Land South of Mortimers Lane,
Fair Oak, Eastleigh

Email Correspondence with the Local Highway Authority regarding the key routes

From: Anthony Jones <AJones@glanvillegroup.com>
Sent: Tuesday, January 30, 2024 12:13 PM
To: Huggett, Jon <Jon.Huggett2@hants.gov.uk>
Cc: Rogers, Zara <Zara.Rogers@hants.gov.uk>; Lamont, Scott <Scott.Lamont@hants.gov.uk>; Rebecca Fenn-Tripp <Rebecca.Fenn-Tripp@bloorhomes.com>; Sarah Hockin <sarah.hockin@turley.co.uk>; Nina Lloyd <nina.lloyd@turley.co.uk>; Will Gardner <willg@edp-uk.co.uk>; Gammer, Nick <Nick.Gammer@hants.gov.uk>; Rusne Bagdanaviciute <RBagdanaviciute@glanvillegroup.com>
Subject: RE: Land to the South of Mortimer Lane, Fair Oak (Pre-app ref 6/3/9/320)

Figure 8
Walking Routes

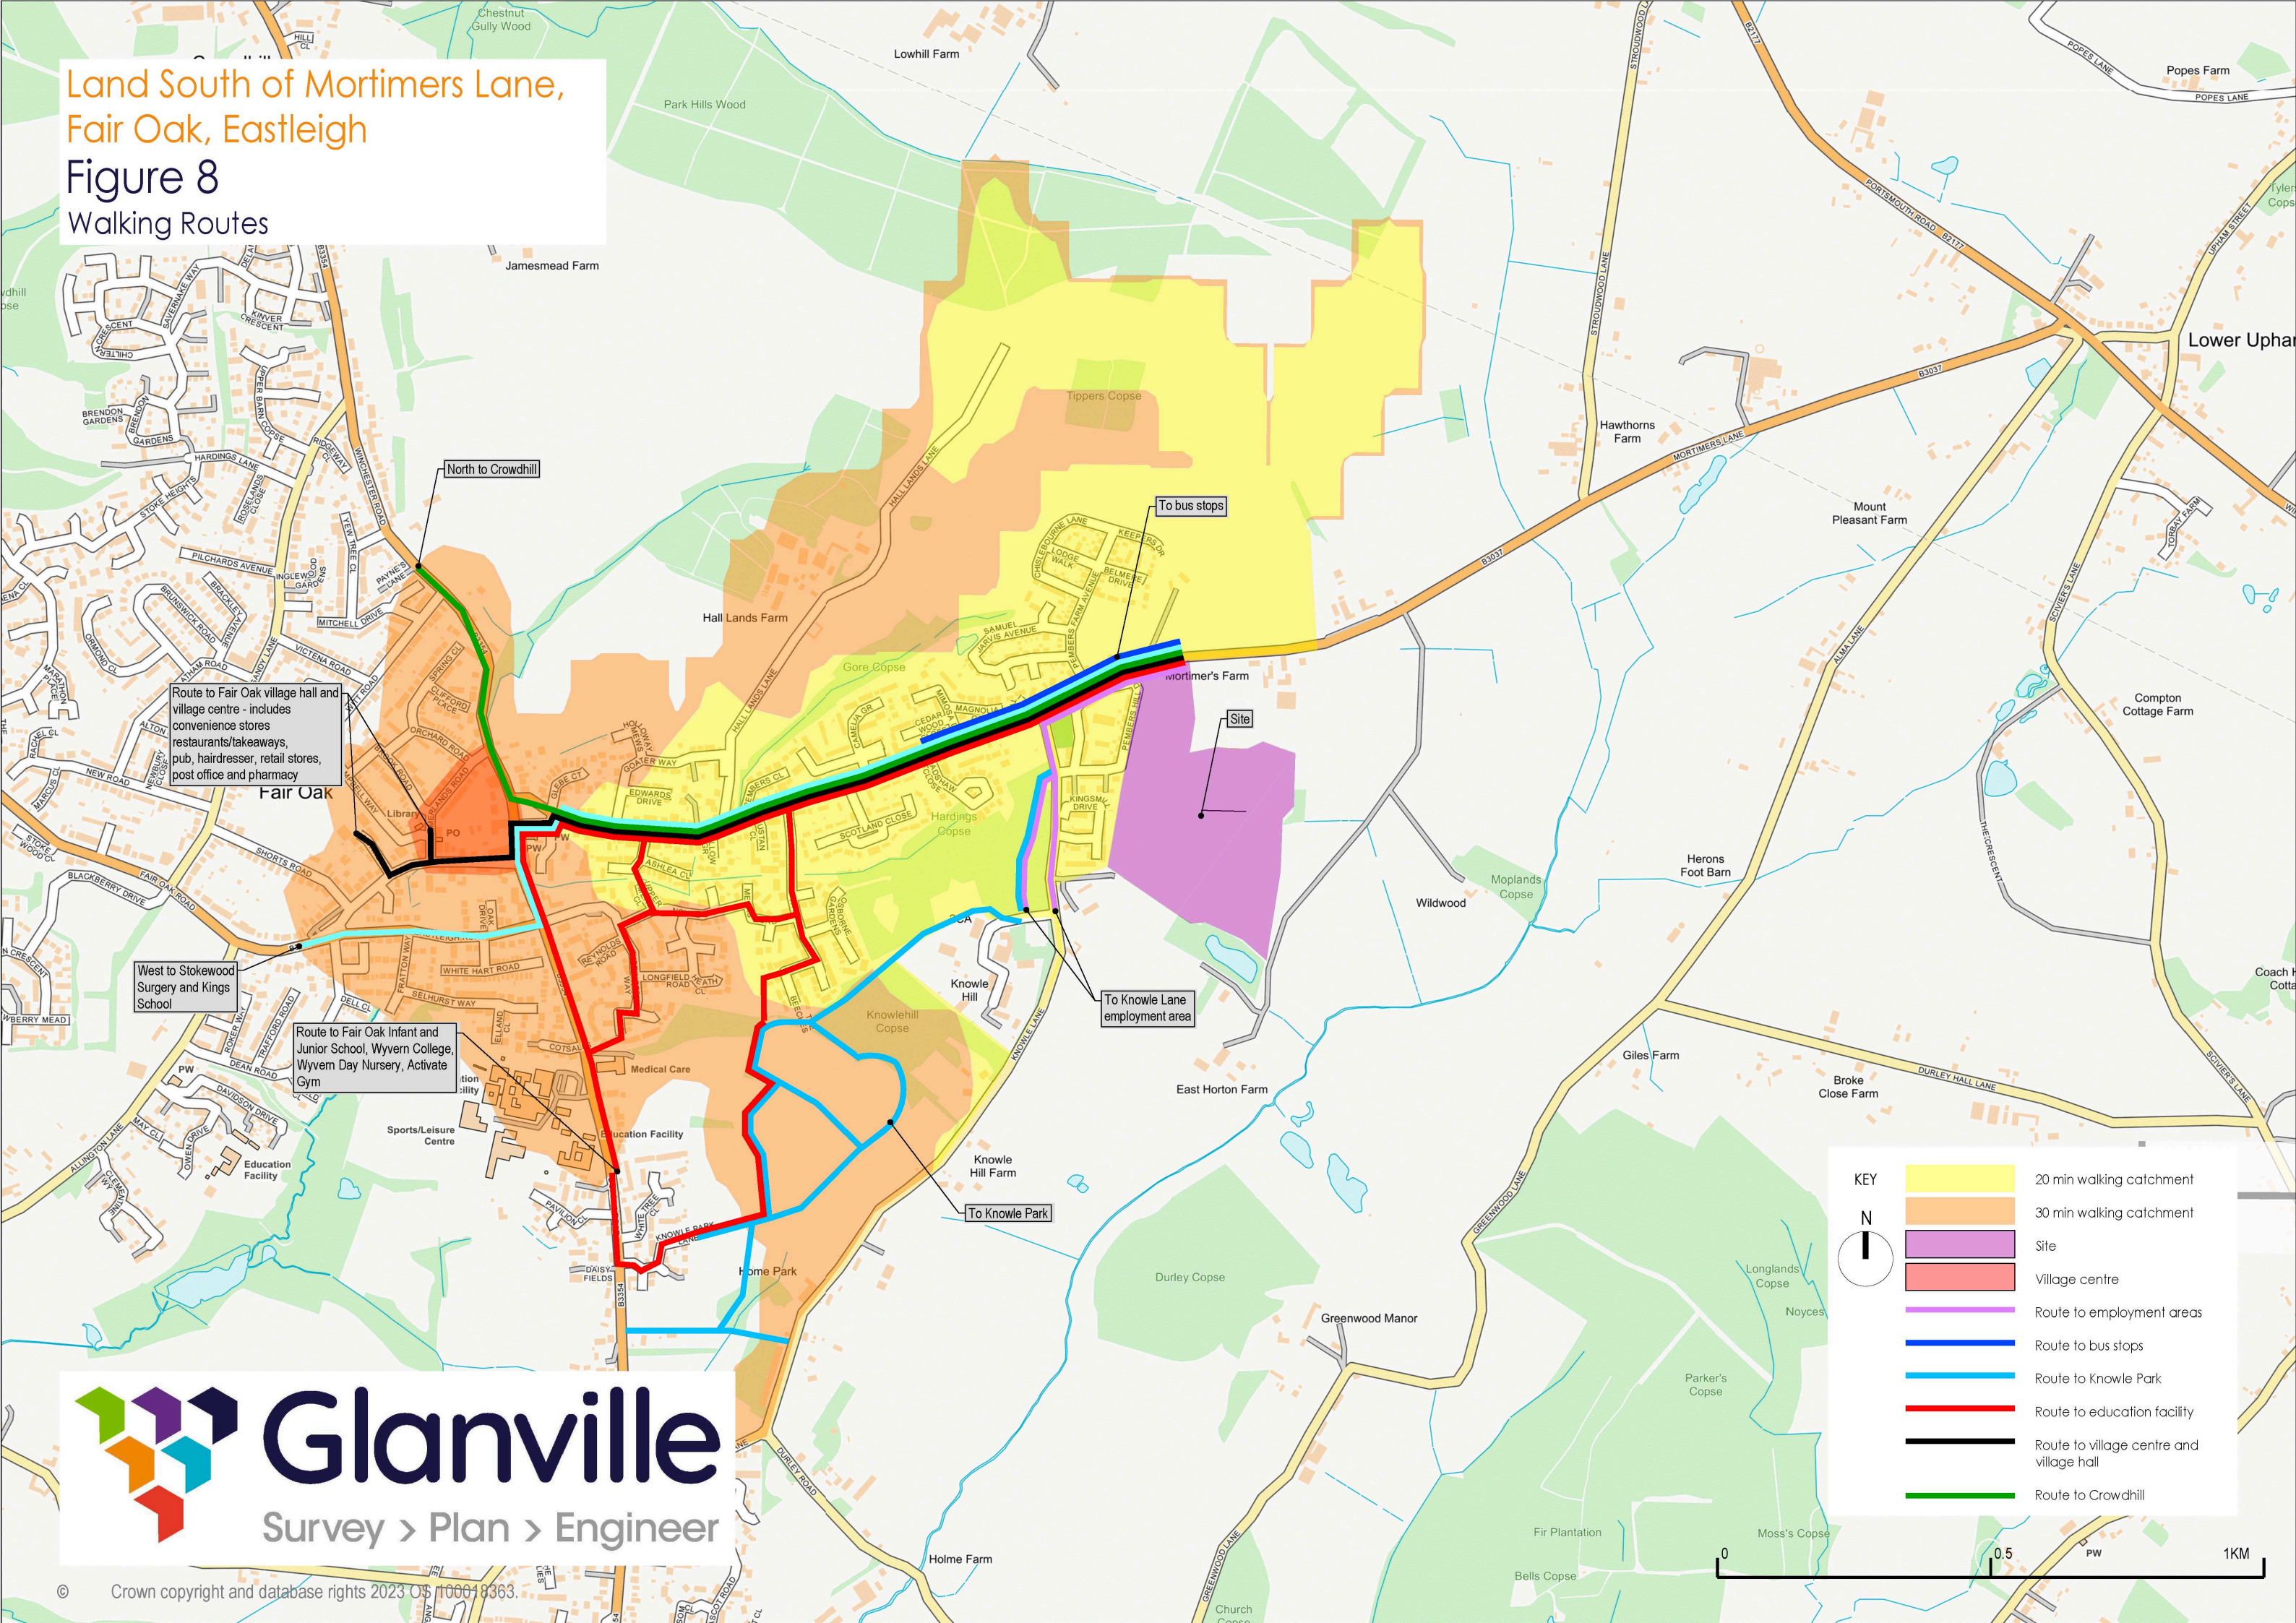
With respect to the Walking, Cycling And Horse Riding Assessment and Review (WCHRA), we note that the HCC TG19 – 'Walking, Cycling And Horse Riding Assessment and Review' Technical Guidance advises that the proposed scheme of 250 dwellings plus the potential on-site community facility is a large scheme as it is more than 50 dwellings. DMRB GG142 – 'Walking, Cycling And Horse Riding Assessment and Review' advises at paragraph 4.6.1 that the WCHAR study areas for larger schemes should cover an area of 5km on surrounding highway network. We note that TG19 doesn't provide specific advice on the proposed study area extents, but we would propose that the WCHRA considers the key walking and cycling routes shown on the attached Drawings 8230679-6008 and 8230679-6009. Can you please confirm that these study routes are acceptable by return. **The walking routes are agreed. In terms of the cycling routes I don't think we need to route to Bishops Waltham or the route to Marwell.**

Are you content that the WCHRA considers only pedestrian, cycle and Horse-Riding related personal injury collision on the routes shown in Drawings 8230679-6008 and 8230679-6009 for a three year study period? **Yes agreed**
